REQUEST FOR INFORMATION	DATE: February 02, 2017	NO.: RFI-435
--------------------------------	--------------------------------	---------------------

Project Name: 15051-Webster University Interdisciplinary Science Building	Project No.: 15051
---	--------------------

Subject: Clarifications at room C270A

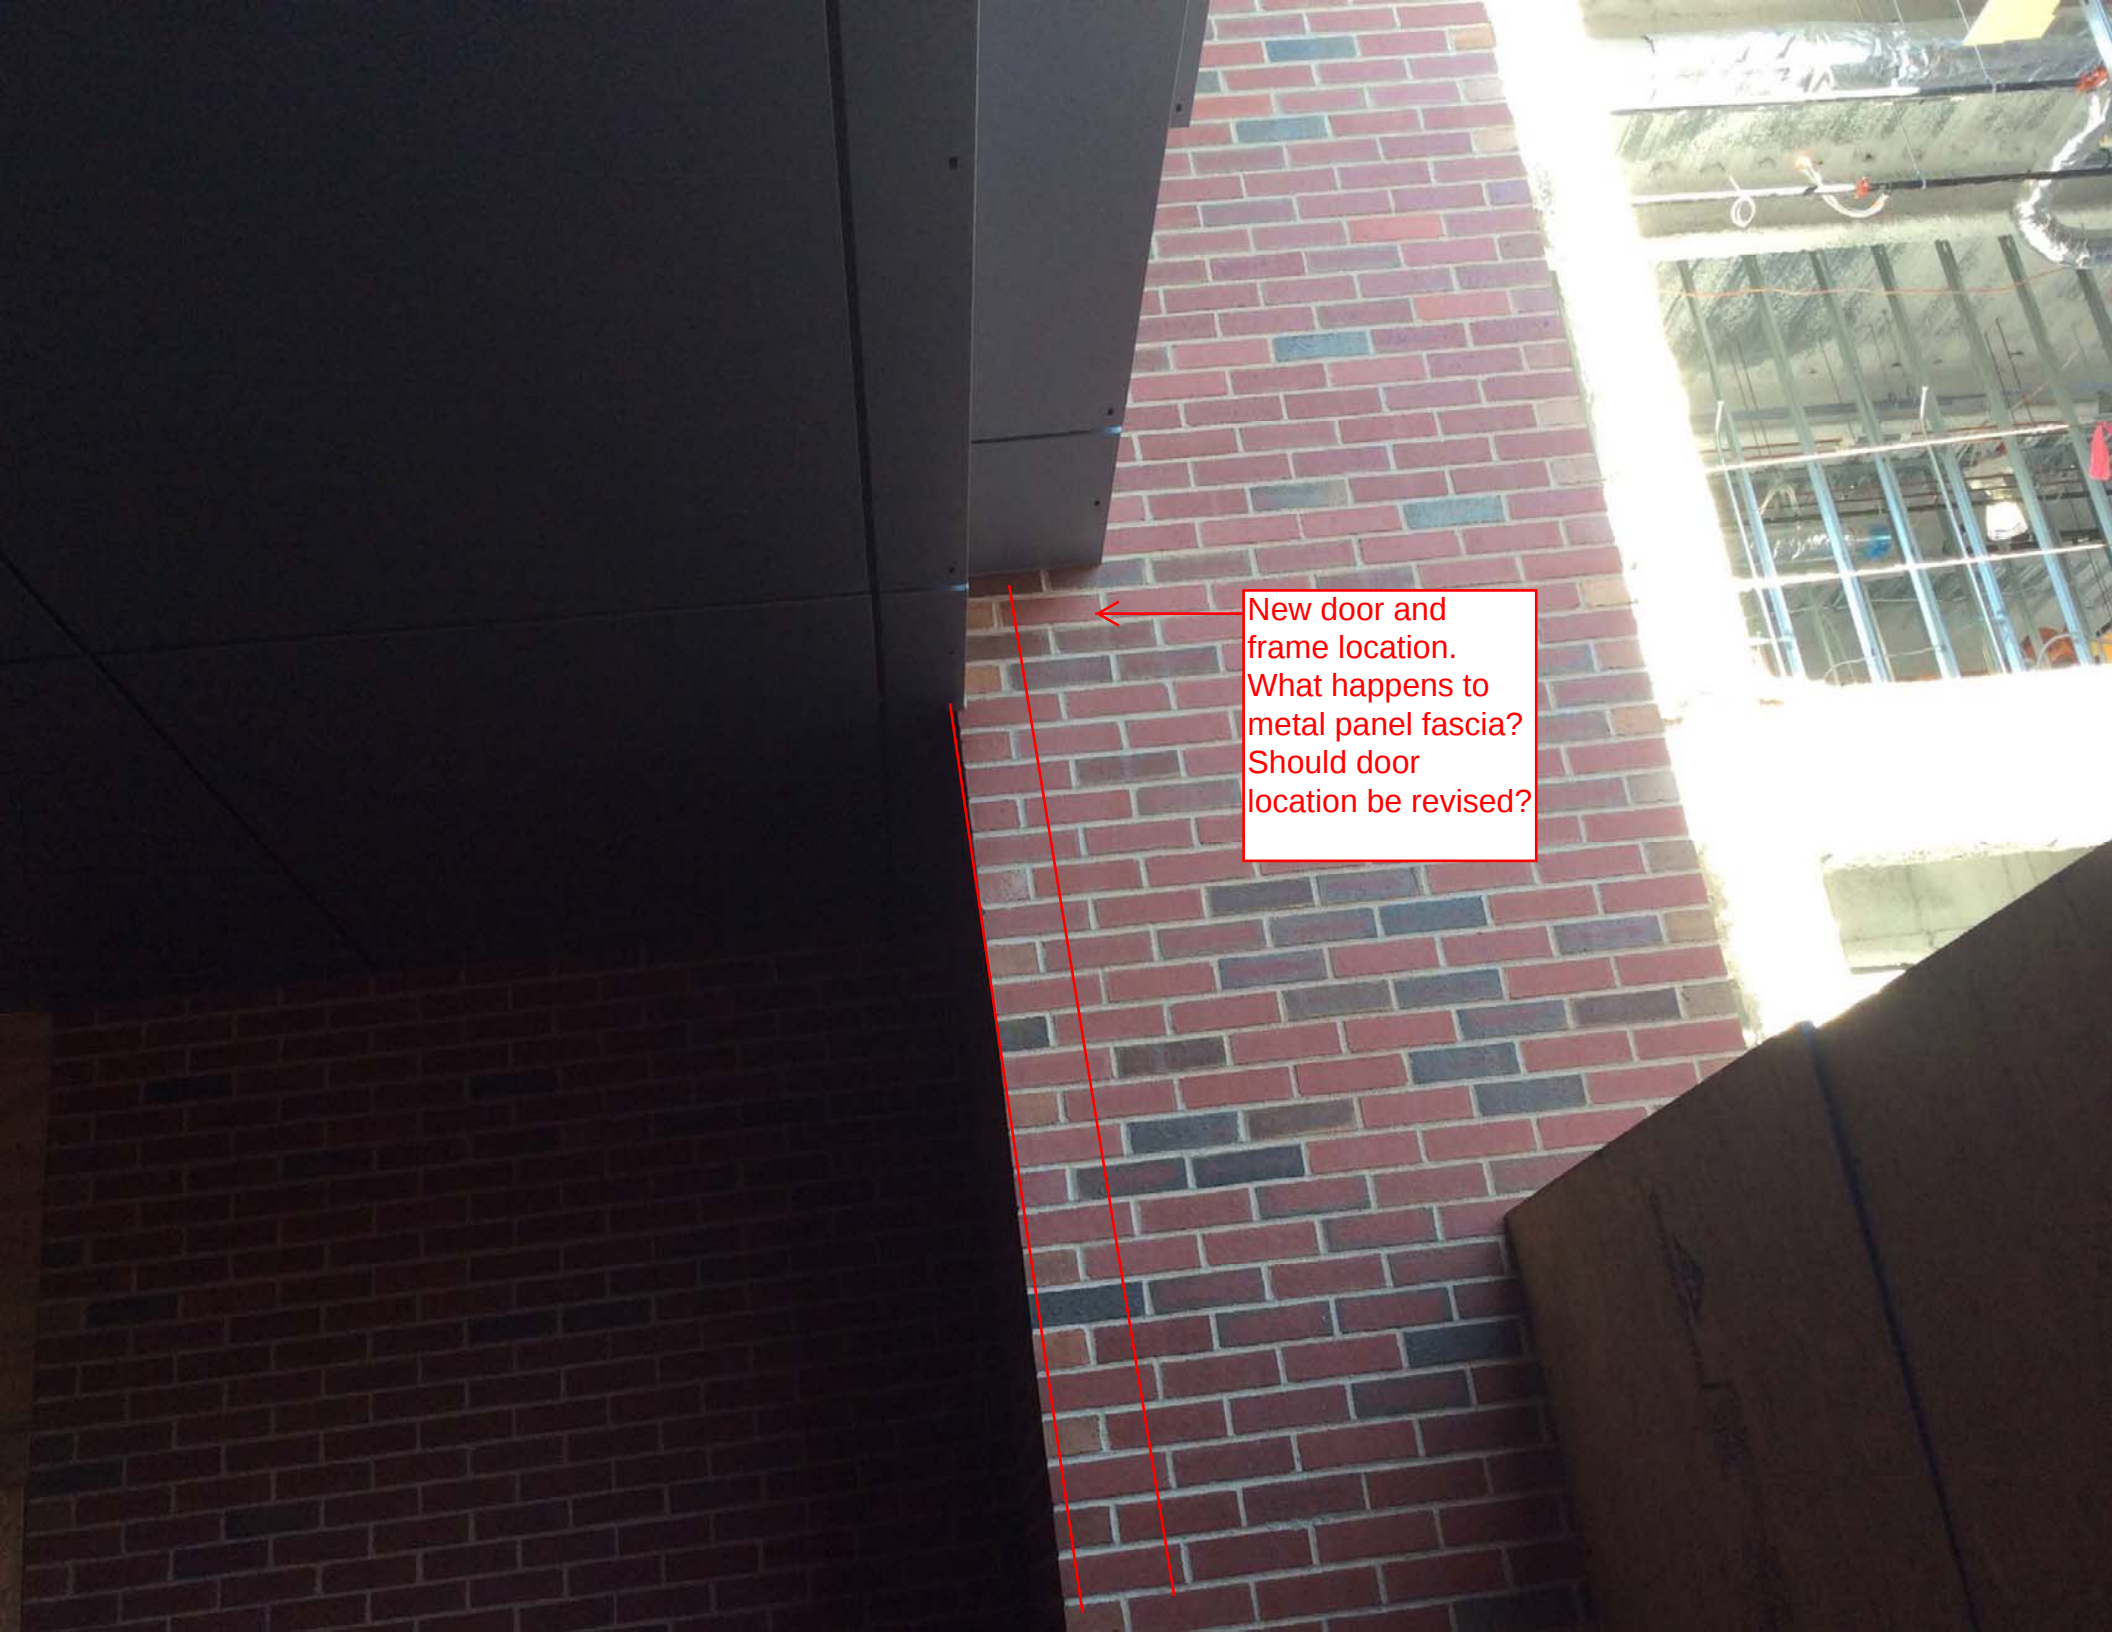
Room C270A shows the new doors to align with the inside corner of the existing brick wall. See attached photo and please advise how the fascia of the metal panels should be treated at this condition, or if the door location should be revised. Also, the existing ceiling is approx. 11'5" and the reflected ceiling plan indicates a new gyp ceiling at 11'4" in the center of this area an unknown square trim piece. Please advise if the intent is to remove the existing metal panel ceiling and replace with gyp? Or should the existing ceiling remain and the reflected ceiling plan be updated to reflect existing conditions?

New door and
frame location.
What happens to
metal panel fascia?
Should door
location be revised?

As discussed on site, the new storefront/door location are to be per drawings. The affected metal panels are to be re-fabricated. Provide a proposal to review.

Response: Design Intent - since we have additional MEP items added to the ceiling, we thought replacing the ceiling with gypsum board ceiling would be the most simple & cost efficient.

If Paric can maintain the existing metal panel ceiling and provide the additional MEP items with some modifications, please submit a proposal for design team's review. If you prefer, we can also have a conference call to discuss with necessary team members.
